June 12, 2002

SUBJECT: QUESTIONS FOR DAVIS-BESSE MANUAL CHAPTER 0350 PANEL

Apparent Failure to Comply with Federal Regulations for Updating the FSAR

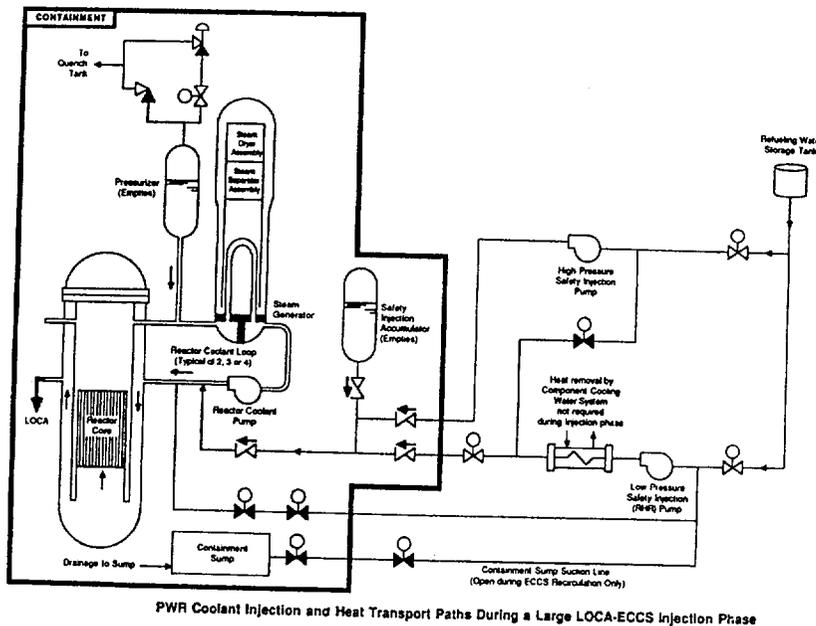
The schematic illustrates the systems involved following a loss-of-coolant accident. The LOCA is represented by the opening on the left side of the reactor vessel allowing cooling water to pour out into the containment building where it drains to the containment sump.

The high pressure safety injection pumps and the low pressure safety injection pumps (one each shown on the right portion of the schematic) initially supply water from the refueling water storage tank to the reactor vessel to compensate for the lost inventory. Thirty minutes to an hour into the accident, the refueling water storage tank empties. Operators close valve (shown as the white bow-ties on the schematic) and open other valves (the black bow-ties) to allow the pumps to take water from the containment sump and deliver it to the reactor vessel.

- UCS-02a **Will the plant-specific evaluation of GSI-191 vulnerability recommended by the NRC staff in its presentation to the ACRS in September 2001 be completed for Davis-Besse prior to restart?**
- UCS-02b **If not, would the NRC staff not be guilty of the exact same, or at least eerily similar, tolerance of degraded conditions that caused the current problem at Davis-Besse?**
- UCS-02c **Will all of the boric acid deposited inside the reactor containment at Davis-Besse be found and removed prior to restart?**
- UCS-02d **If not, what assurance exists that this debris won't be transported to the containment sump and contribute to sump failure?**
